## Product Change Notification - SYST-07YGCW636

ERRATA - SAM G55 Series Family Silicon Errata and Data Sheet Clarifications

## SAM G55 Series Family Silicon Errata and Data Sheet Clarification

## Data Sheet Clarifications

## 8. Module: Transmitter Operations

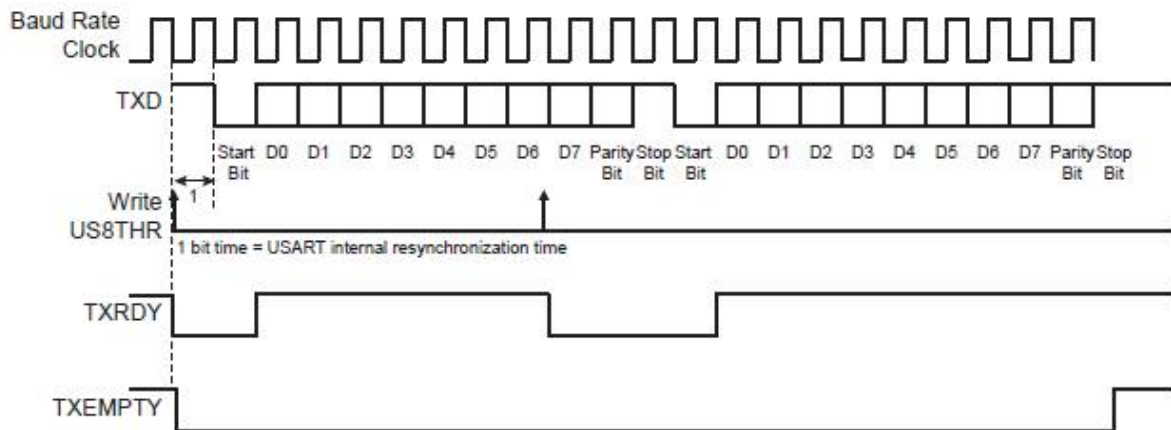
Figure 30-6 is incorrect. The corrected figure is as follows:
